**MoPac South Environmental Study  
Public Comments Received**

Event (OH=Open House)	Last Name	First Name	Date	Method Received	Comment (verbatim)
OH#4	Abernathy	Maria	11/17/15	Web Mail	<p>After viewing maps, reading, and participating in discussions of the CTRMA proposals for South Mopac, I still do not support any elevated lanes over MoPac in the area of Lady Bird Lake and Zilker Park. IF any of the proffered options must be chosen, the option with toll lanes but no elevated lanes would be the least offensive.</p> <p>However, I don't agree that any of these options, which add huge amounts of pavement to this beautiful and environmentally sensitive area of Austin, must be built - I urge CTRMA, businesses, and local governments to consider other ways to reduce congestion on Mopac during peak commute hours: staggered work schedules, increased use of telecommuting, rail lines, and NO connection of MoPac to IH35 through the extension of SH45. Please consider also that diverting large truck traffic to TX 130 (and making it toll-free) could significantly contribute to faster commuter traffic on MoPac and IH35.</p> <p>Thank you.</p>

**(2) The Mopac South Environmental Study needs to study and evaluate an alternative that includes 2 HOV lanes in each direction.**

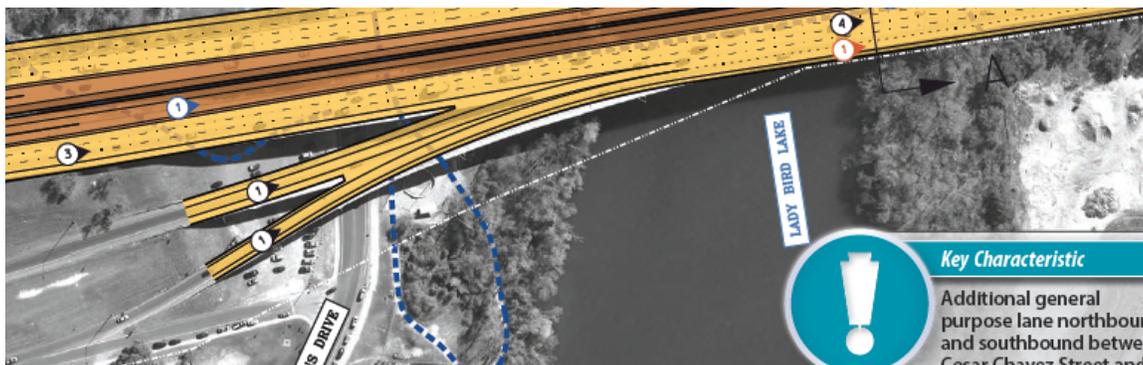
CTRMA staff appears to have initially compared the travel time estimates and impact of 1 HOV lane in each direction on Mopac South with 2 toll lanes in each direction on Mopac South. This is not an even or fair comparison of alternatives to toll lanes. An alternative with 2 HOV lane in each direction, optimized with TDM and TSM strategies, should be considered along with 2 toll lanes in each direction, optimized with the same or even TDM and TSM strategies.

**(4) The Mopac South Environmental Study needs to present all alternatives with the Bee Caves northbound on-ramp entry length returned to the current length or longer.**

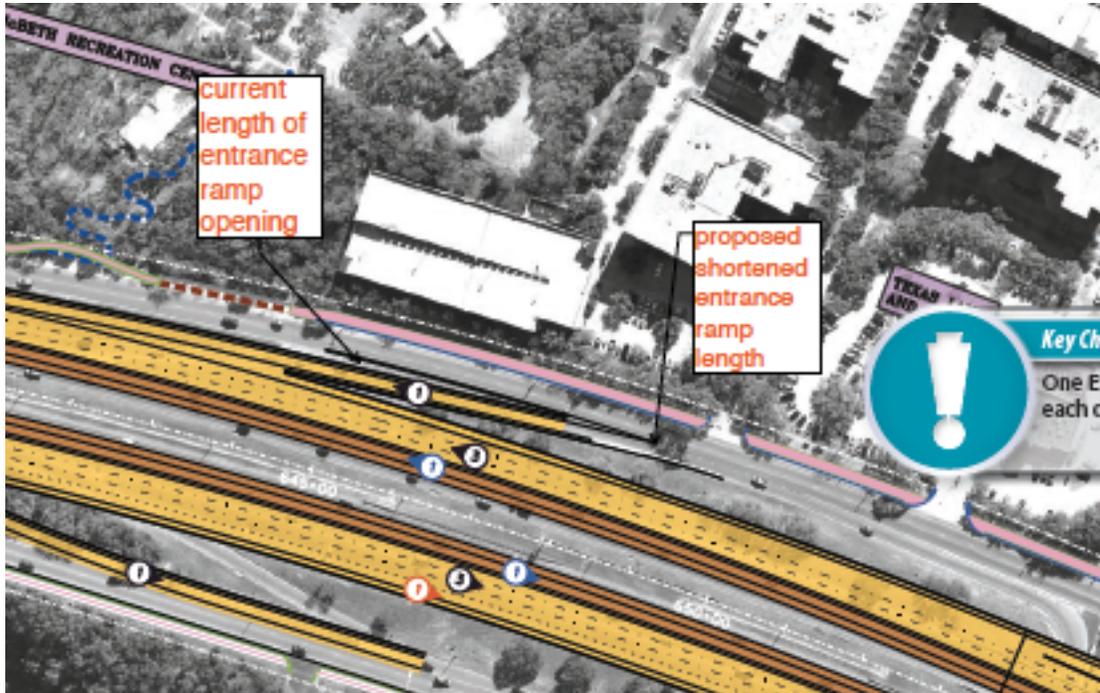
5 of the alternatives presented propose shortening the entry length of the northbound on-ramp from Bee Caves Road. I have marked a cut out of the map for the 2 express lanes in each direction without direct connect to show the point where the on-ramp entry currently ends. In addition, I have marked the map to show the point where the on-ramp entry is proposed to end in the 5 alternatives. (see map below). In future presentations of alternatives, CTRMA needs to clearly show that the northbound on-ramp entry length is the same or longer than the current length. Any shortening of the entry length of this on-bound ramp will create a bottleneck for traffic flow on the frontage road, which will lead to additional traffic backup on Bee Caves Road. Please ensure that the alternatives do not remove existing access, capacity and infrastructure.

**(5) The Mopac South Environmental Study needs to present a Topographical model and traffic simulation of the Proposed Bee Caves Southbound exit ramp.**

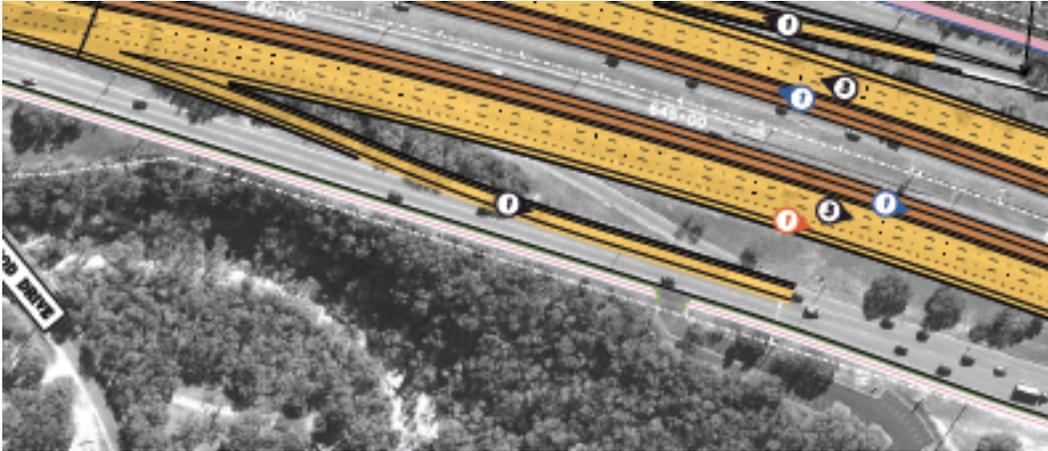
5 of the alternatives propose adjusting the position of the exit ramp at Bee Caves road for southbound traffic (see map below). Currently, it is difficult to exit at Bee Caves/2244 and merge across all the lanes of traffic, to arrive at the westbound lane of Bee Caves Road. Backing up the exit ramp to provide extra space for merging may reduce this dangerous merging condition. In addition, the topography of the frontage road significantly contributes to the dangerous merging condition. Cars accelerate up the steep incline, which terminates with a sudden rise, and then levels out proximate to the driveway into Parks Hills church. The accelerating cars reach the rise and then intersect with cars exiting the ramp and attempting to merge across multiple lanes of traffic.

At the next Open House, CTRMA should present a topographical model of the proposed Bee Caves Southbound exit ramp for each of the alternative. Engineers for CTRMA have noted that different alternatives require different amounts of right of way, which impacts the design constraints for positioning and lengthening the Bee Caves Southbound exit ramp.

In addition, at the next Open House, CTRMA should provide a traffic simulation of the traffic merging into the frontage lane, showing where vehicles will enter the frontage road, using real modeling of the speeds at which vehicles travel up the steep incline and showing the inclines. Traffic modeling should show impacts at peak and non-peak hours.

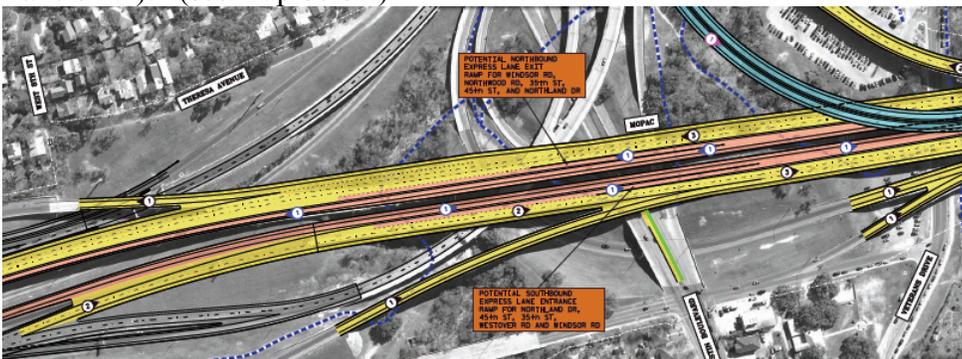
There are many other toll road entrance/exit points along the Mopac South Project corridor that require toll lane traffic to merge in and out of an inside lane, and service multiple exits, rather than a single exit.

In all 6 alternatives, CTRMA has placed a toll road exit for northbound toll traffic at the top of the north side of the Lady Bird Lake bridge, before the Enfield exit (“the Enfield Toll Lane exit”). (see map below)

The Enfield Toll Lane exit is the only toll road exit point for all northbound toll road traffic needing to exit Mopac at the following exit points: Windsor Road, Northwood Road, 35<sup>th</sup> street, 45<sup>th</sup> street, and Northland Drive. **CTRMA has selected, as part of the Mopac South project, to place a single toll road exit point, from an inside lane, to service toll lane traffic exiting from 5 exit points on Mopac.**

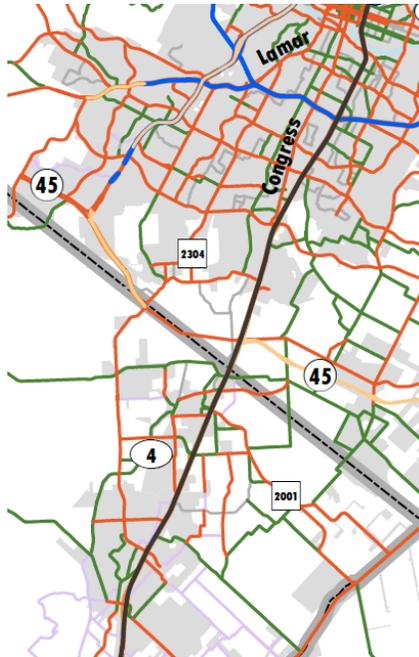
Despite the fact that the CAMPO 2040 plan is the active plan during the current open house, and despite the fact that the CAMPO 2035 plan fails to provide authority for CTRMA to study, design, or evaluate 2 express lanes in each direction, during the November 2015 Open House, CTRMA staff have continued to evaluate the travel times for each of the 6 alternatives (4 of which include 2 express lanes in each direction) based on the Traffic Demand Model provided by the CAMPO 2035 plan, modified by 2015 blue tooth data.

The CAMPO 2035 plan does not take into account Regional Toll Network Analysis and Traffic Demand Model based on the CAMPO 2040 plan. The Regional Toll Network Analysis and Traffic Demand Model for the CAMPO 2040 plan should take into account, in the demand on Mopac South, that 2 express lanes in each direction are allowed. According to CTRMA, one express lane in each direction is not a financially viable option for taking the Mopac South project out for bonding. If this is true, then it stands to reason that the Traffic Demand Model for 2 express lanes in each direction would differ from the Traffic Demand Model for 1 express lane in each direction in the CAMPO 2035 plan. In addition to financial viability, CTRMA has all but eliminated the option for one express lane in each direction on Mopac South by in comparison with two express lanes in each direction. There are differences in capacity, ability to handle emergencies, financial viability, and average travel times.

In addition, the CAMPO 2040 plan has a significant error, which should be corrected as CTRMA participates in evaluating the effects of the Mopac South toll road on the EJ community in accordance with NEPA. For the Regional Toll Network Analysis CTRMA is required to perform, as part of the NEPA analysis, to be accurate. Page 152, column 3 of the CAMPO 2040 plan under “Regional Toll Network Analysis” states “The interconnected network of existing and planned toll roads and express lanes form a regional toll network. Project sponsors evaluate the effects of the toll roads and express lanes on the EJ community for individual road projects in accordance with the National Environmental Policy Act (NEPA). CAMPO also evaluates the regional toll network for the effect of the total interconnected network on the EJ community. CAMPO will conduct the 2040 Plan Regional Toll Network Analysis (RTA) after the Transportation Policy Board adopts the 2040 Plan. CAMPO’s most recent RTA includes all planned and potential toll projects, except for the IH 35 express lanes.” This statement is not correct. CAMPO’s most recent RTA based on the 2035 plan only includes potential toll projects of one express lane in each direction on Mopac South. The CAMPO 2040 plan includes two express lanes in each direction on Mopac South. CTRMA has made assertions as to the significant differences in the effects of one toll lane in each direction and two toll lanes in each direction. The RTA based on the CAMPO 2040 plan should be updated to include potential toll projects of two express lanes in each direction on Mopac South.

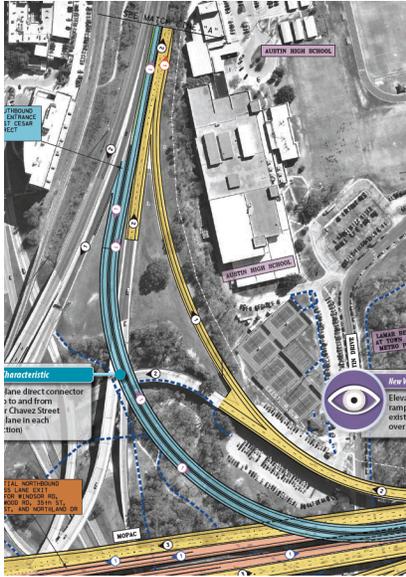
Please consider adding the Bee Caves road interchange, which is a gateway to Bee Caves Road and Barton Springs, to be improved as part of the Mopac South Environmental Study. If

CTRMA continues to decline this request, please provide the public with a written rationale for the Bee Caves intersection not being updated and improved as part of the Mopac South Intersections Study or Mopac South Environmental Study. Of note, in the “Proposed Action, Purpose and Need Statement” released in June 2015 for the Intersection Environmental Studies, Table 2 on page 6 provides data about the amount of delay per vehicle and number of vehicles using the Slaughter and La Crosse interchanges at peak times. In your rationale, please provide similar traffic analysis regarding the amount of delay per vehicle and number of vehicles using Bee Caves interchange at peak times and explain why improvements are not recommended for this interchange.

In addition, please consider that the expansion of Bee Caves Road to include a center turn lane and bike and pedestrian facilities is already underway to support the predicted increase in traffic volumes on Bee Caves Road.

## Direct Connection Over Lady Bird Lake Design - Dropped right at Cesar Chavez with no merge AM & PM periods

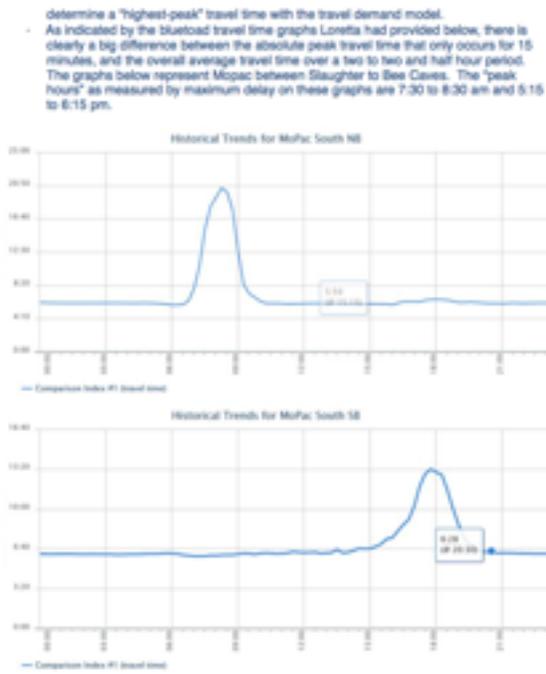
Merge with 2244 Traffic - AM Peak Period

Merge with Northbound Traffic and enter express lanes right before 2244 - PM Peak Period
